RE: Response to TCEQ NOD 3 Addendum – CCR105
Luminant Generation Company LLC – Tatum, Rusk County
Industrial Solid Waste Registration No. 31277
EPA Identification No. TXD000821306
Tracking No. 27220868; RN102583093/CN603256413

Table 1 - NOD Summary and Response
Registration No. CCR105 - Luminant Generation Company LLC
Application Deficiencies - Addendum to NOD 3

RE: Response to TCEQ NOD 3 Addendum – CCR Registration No. CCR105
Martin Lake Steam Electric Station - Rusk and Panola Counties, Texas
(SWR 31277; RN102583093; CN603256413; EPA ID No. TXD000821306)

Ash Pond Area Cross Sections and Associated Figures

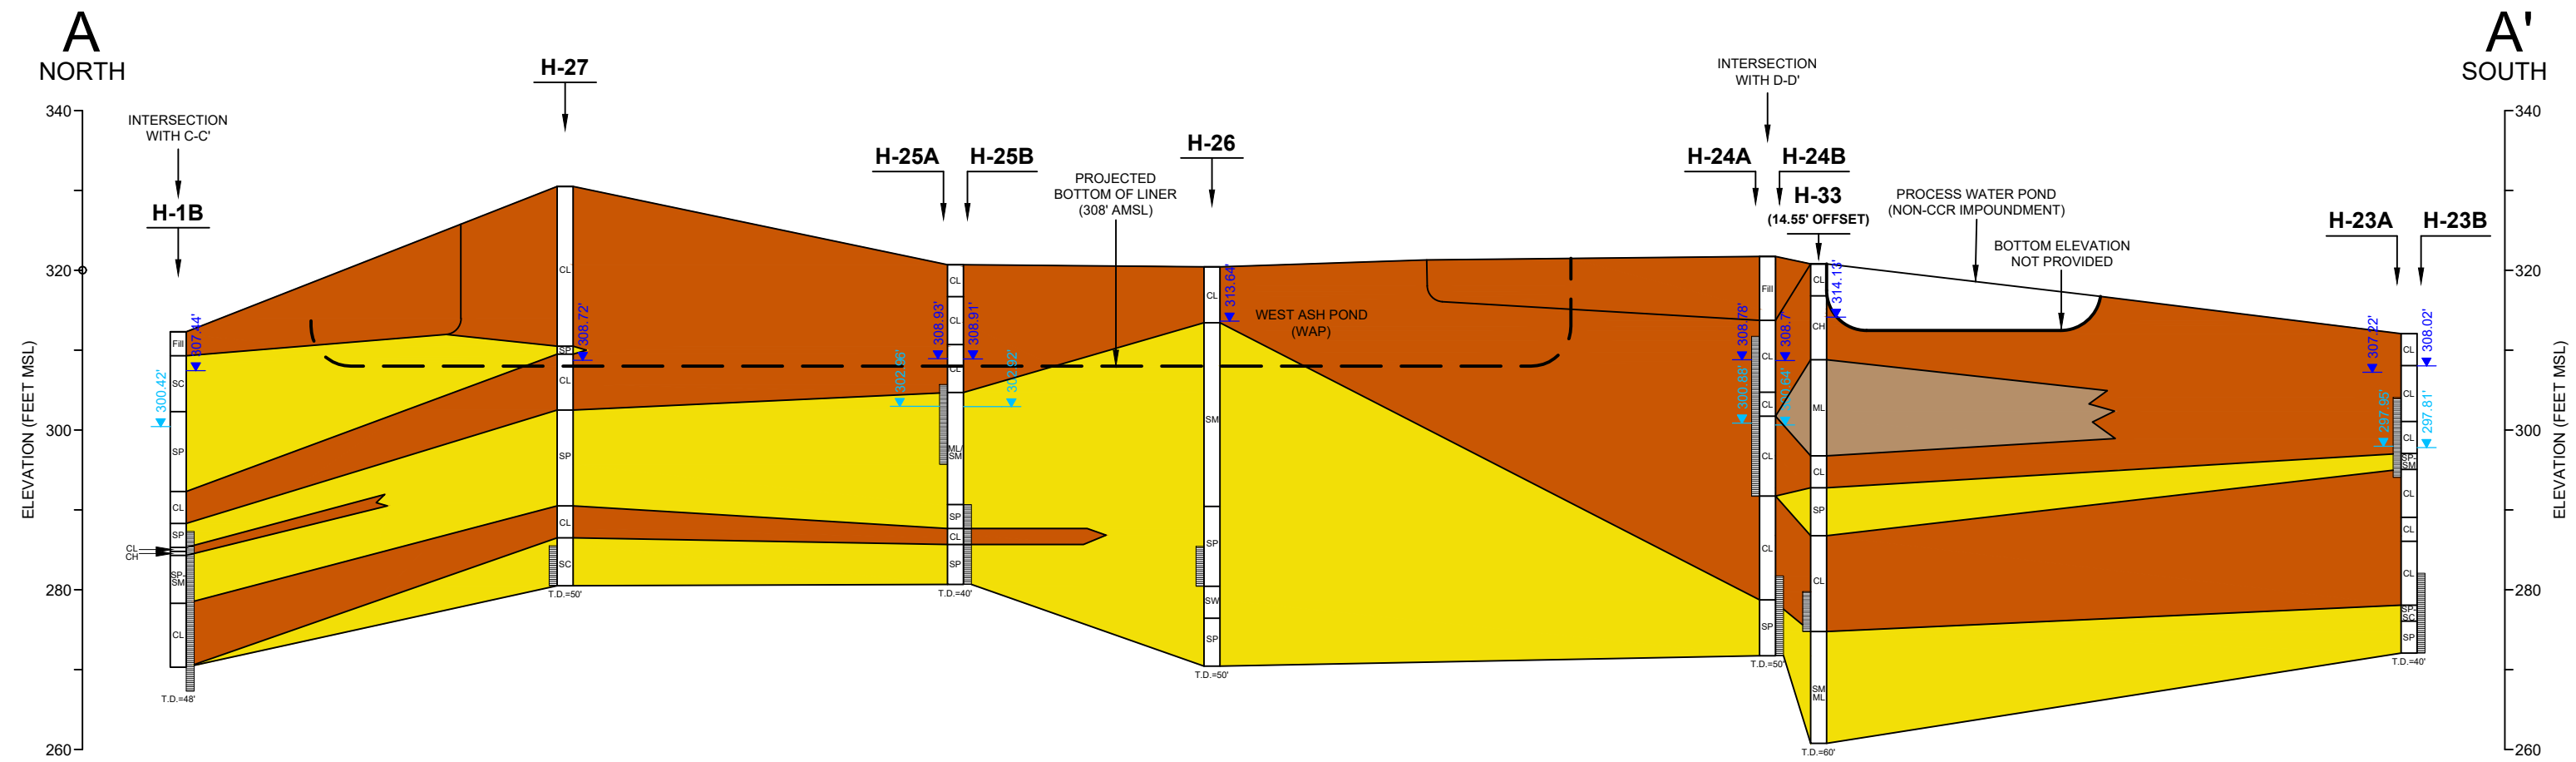
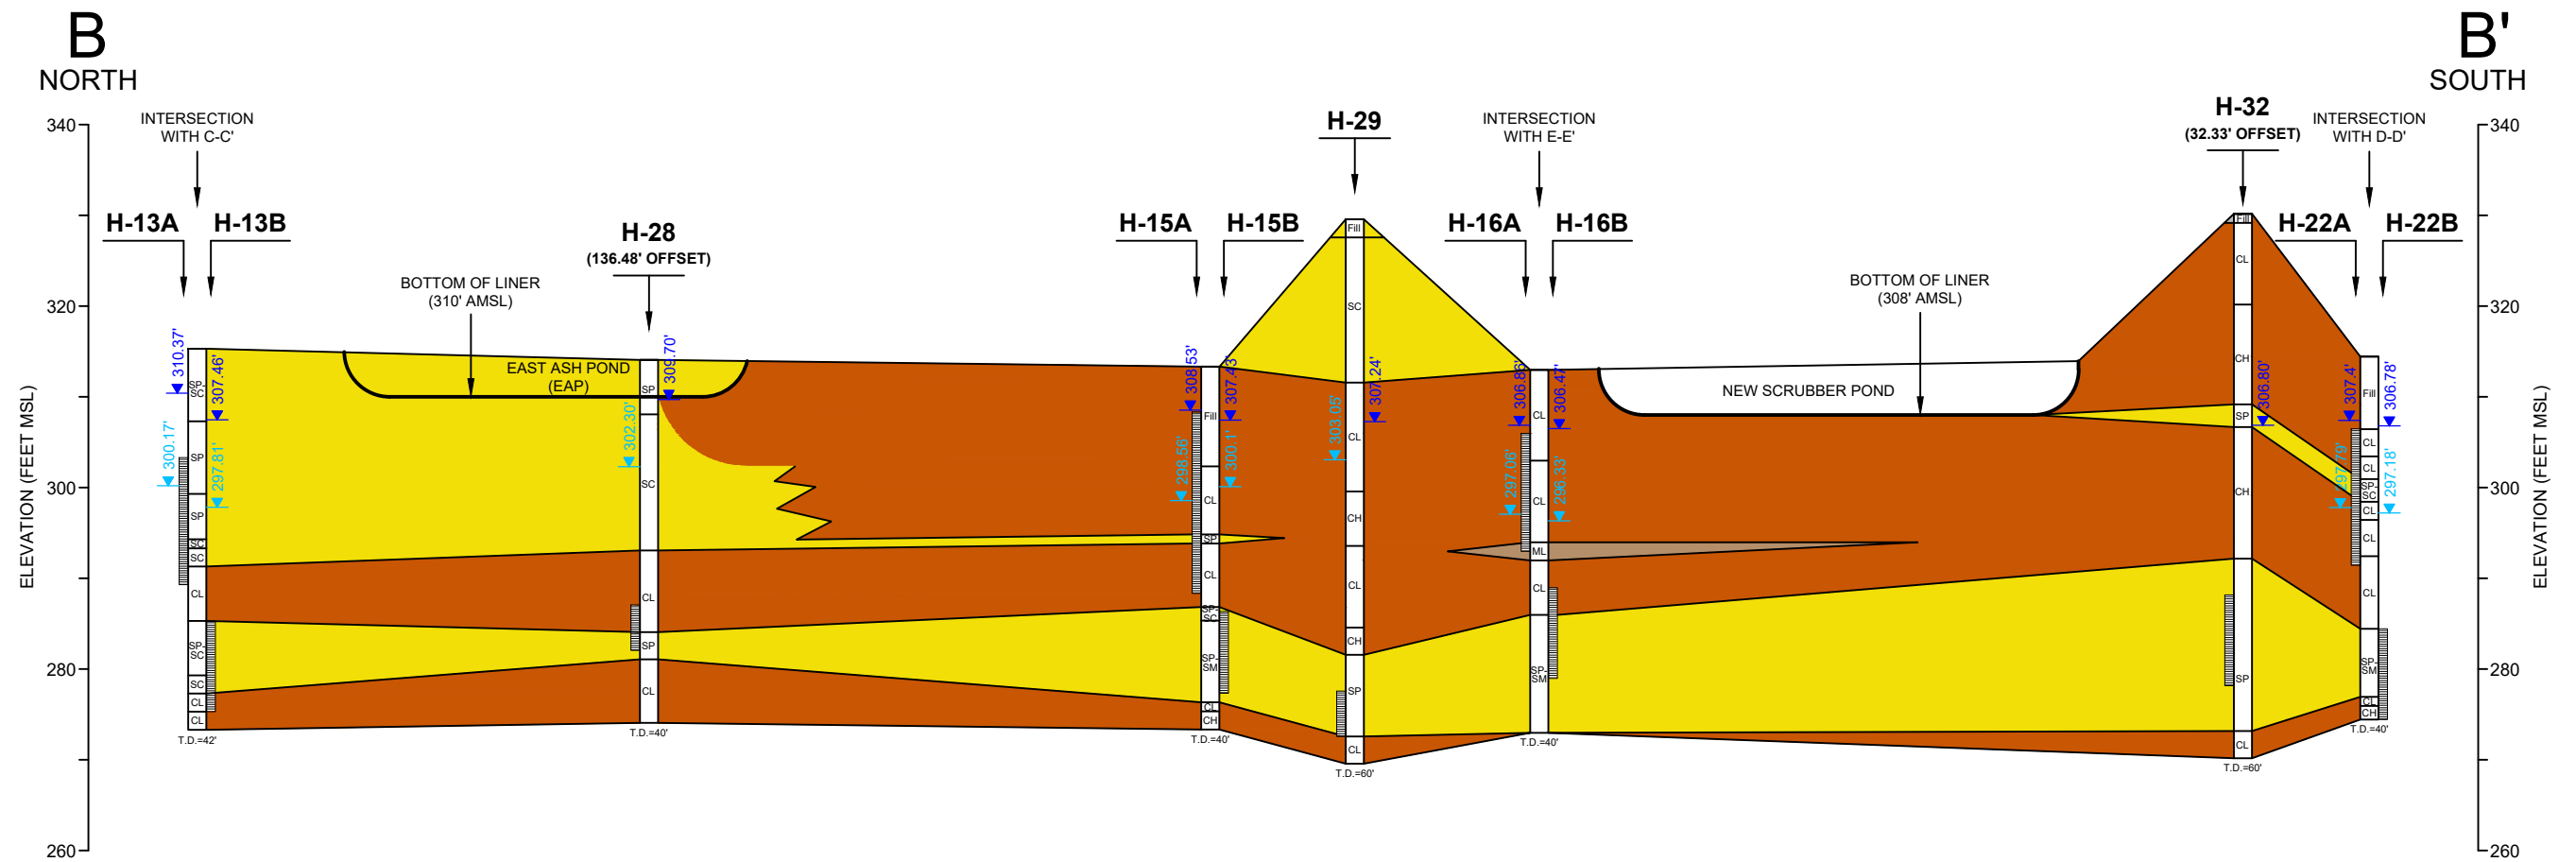
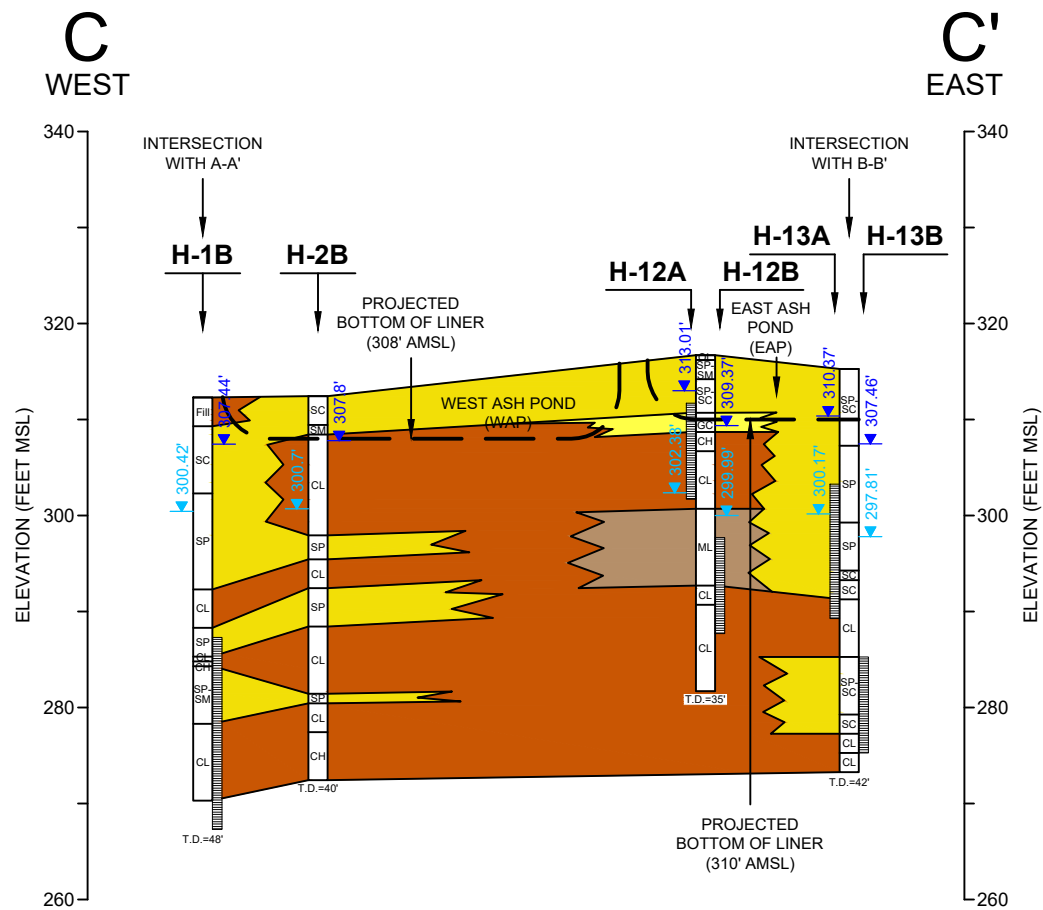
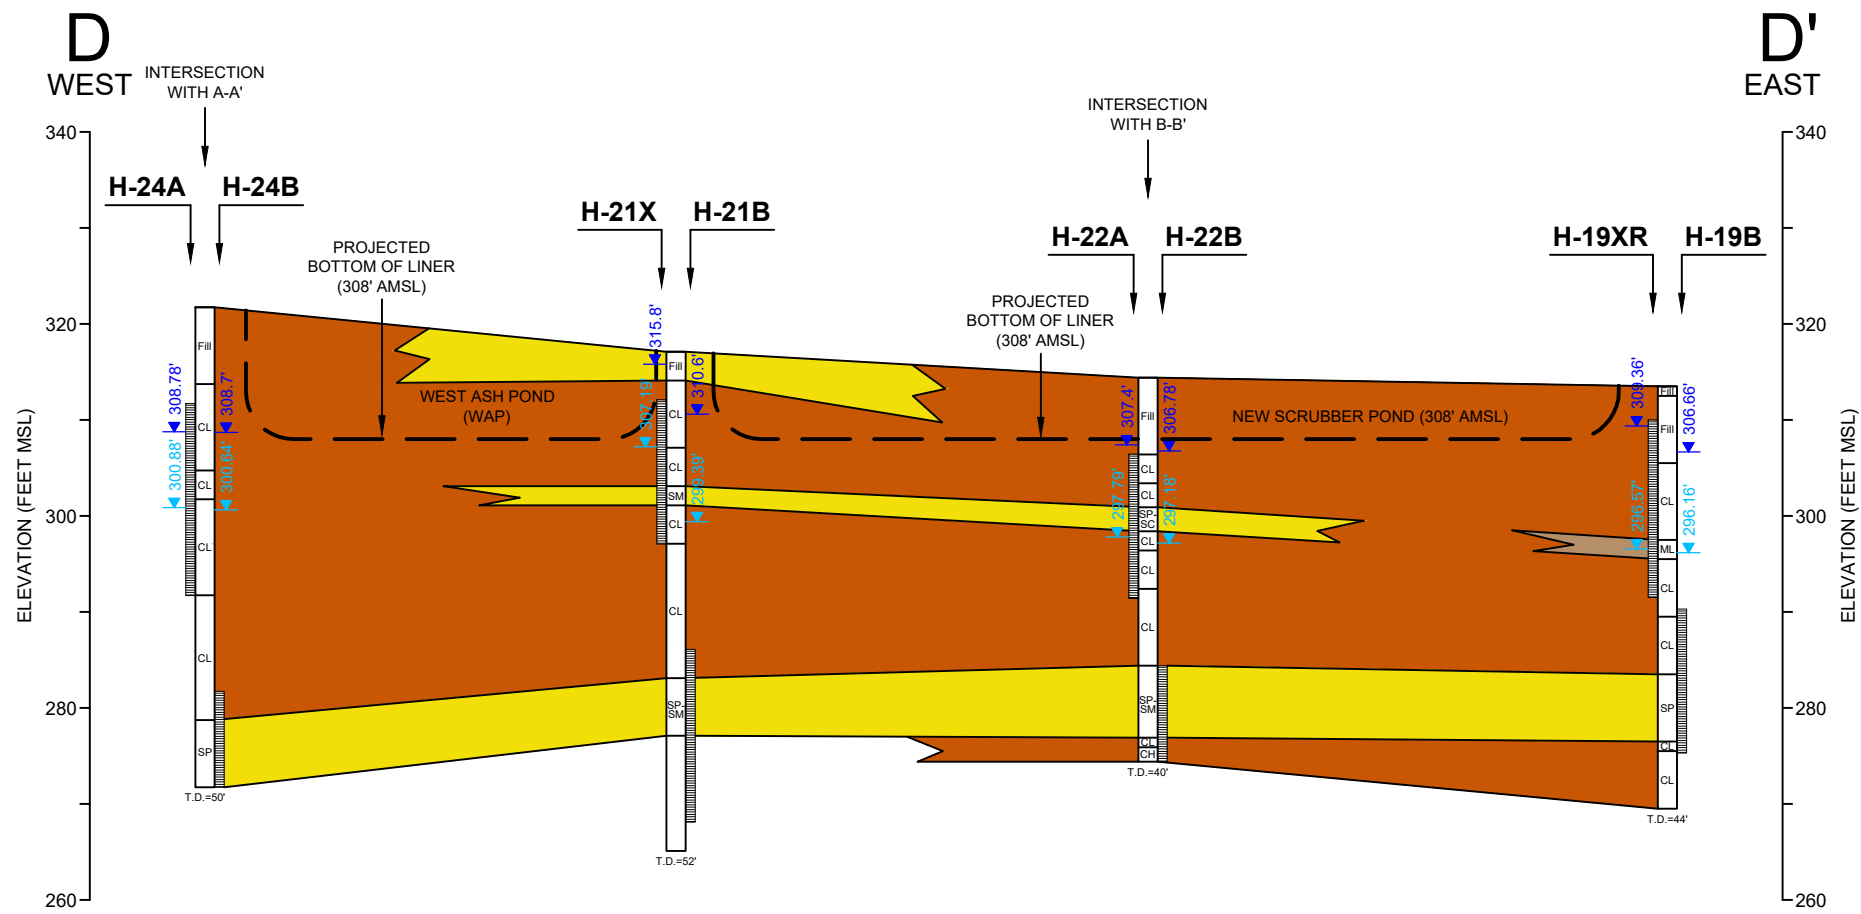
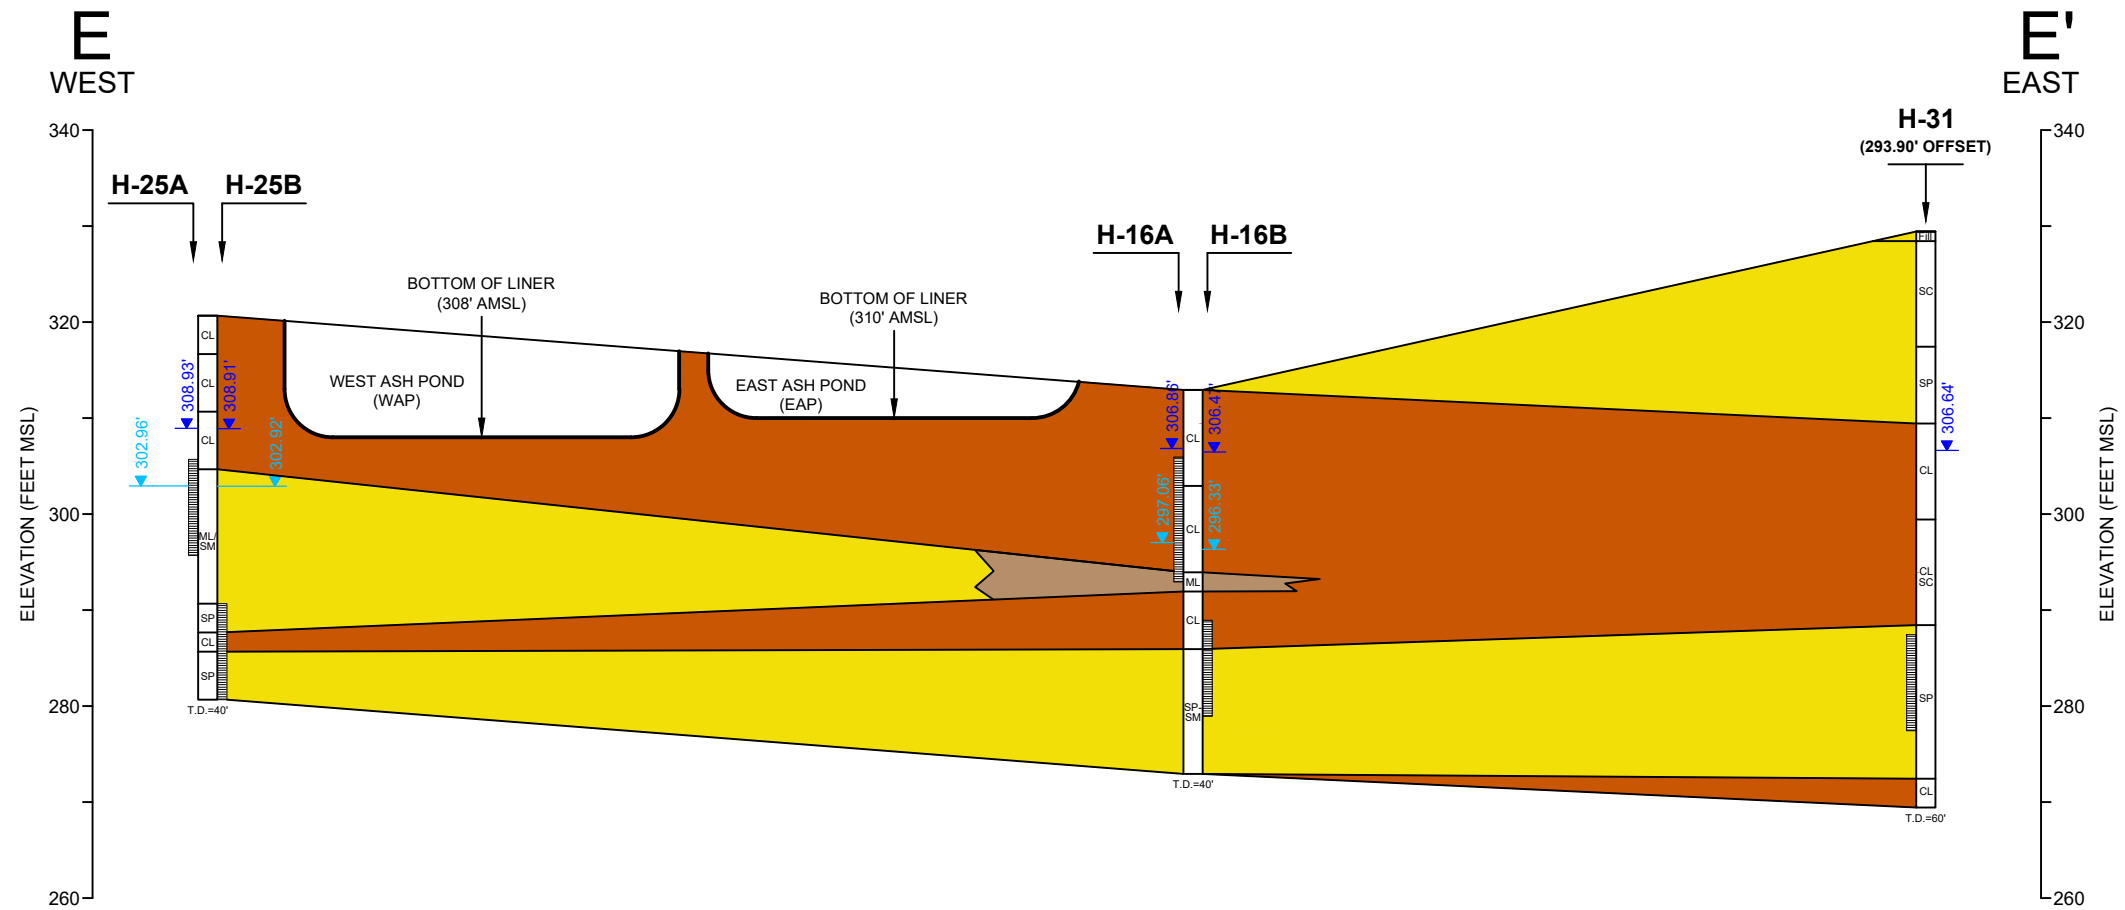
Provide information on using H-26, H-27, and H-33 as background wells as the groundwater may be affected by the operations of the facility (e.g. coal piles) to the west, which is upgradient (based on applicant-supplied groundwater flow maps) to these background wells. This may be based upon:
